**CERTIFICATE OF APPROPRIATENESS**

**Property:** 610 Marshall Street, Lot 1, Tract 5A-1, Block 14, Montrose Subdivision. The property includes a 2,034 square foot house with wood deck at rear and a frame detached garage, situated on a 6,000 square foot (50' x 120') interior lot.

**Proposal:** Alteration – Addition (already built, multiple citations for working without a permit) Applicant seeking approval for completed addition at the side/rear of the historic residence.

**Recommendation:** Denial - does not satisfy criteria: 4,5,8,9

**EAST ELEVATION – SIDE**

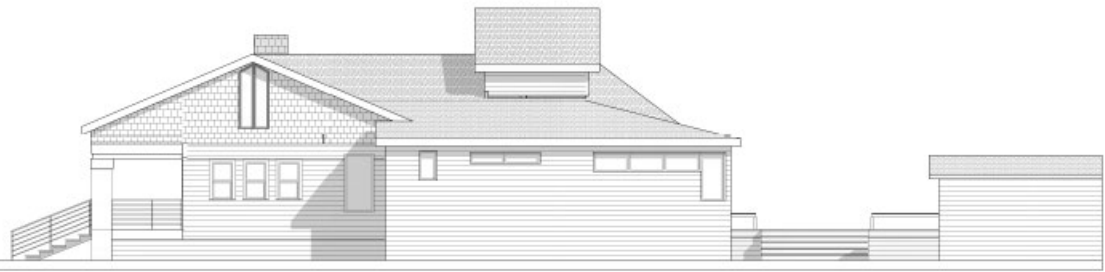
| <input type="checkbox"/>            | <input checked="" type="checkbox"/> | <input type="checkbox"/>            | (4) The proposed activity must preserve the distinguishing qualities or character of the building, structure, object or site and its environment;<br><i>Proposed addition removed historic fabric, specifically the rear corner of original building and historic windows (East elevation). . See HAR photo c. 2013.</i>   |
| <input type="checkbox"/>            | <input checked="" type="checkbox"/> | <input type="checkbox"/>            | (9) The proposed design for any exterior alterations or addition must not destroy significant historical, architectural, archaeological or cultural material, including but not limited to siding, windows, doors and porch elements;<br><i>Proposed addition removed historic fabric, specifically historic windows on East Elevation. See HAR photo c. 2013.</i> |

- Replace the single fixed window on the east (side) elevation immediately prior to the addition bump out with a 1/1 window of the same fenestration, height and size as the three windows to its left.
- Replace the four fixed contemporary windows on the east (side) of the addition with a pair of windows located on the wall similarly to the location of the original pair of windows visible in the recently provided photo of the house taken while the unpermitted work was being completed and on page 23 of this report, subject to staff's approval.

**PROPOSED DEMOLITION PLAN**  
(ALREADY COMPLETE, ORIGINAL BUILDING DEMOLISHED IN RED )

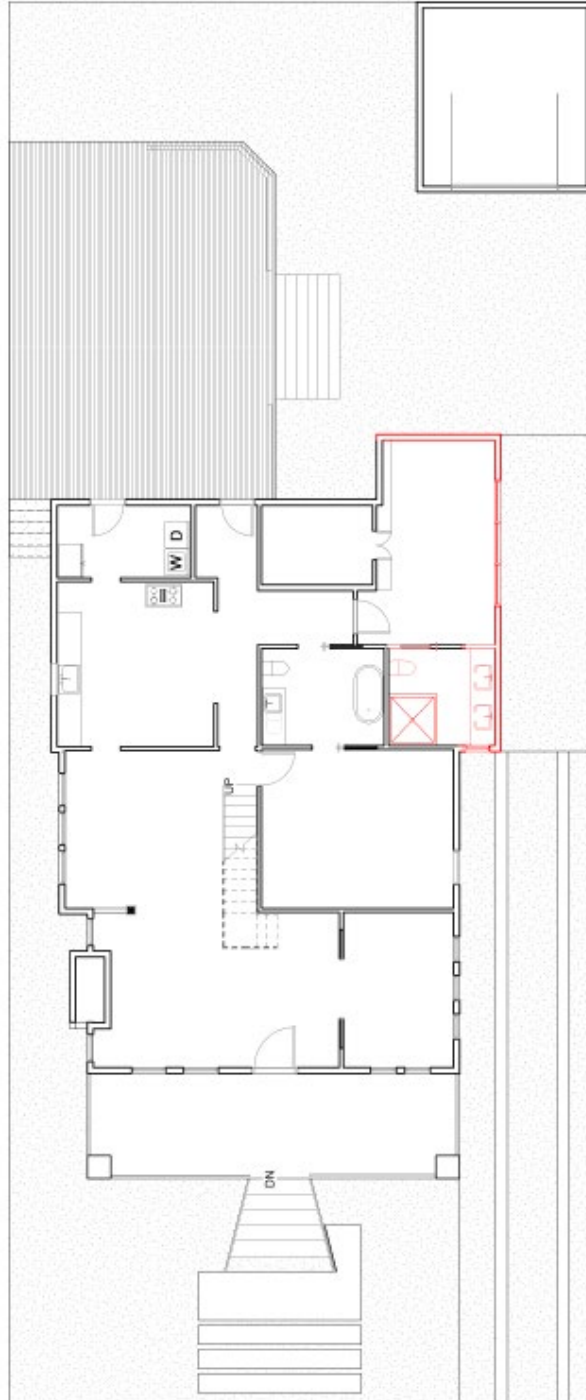
| <input type="checkbox"/>            | <input checked="" type="checkbox"/> | <input type="checkbox"/>            | (8) Proposed additions or alterations must be done in a manner that, if removed in the future, would leave unimpaired the essential form and integrity of the building, structure, object or site;<br><i>Proposed addition removed historic fabric.</i>  |
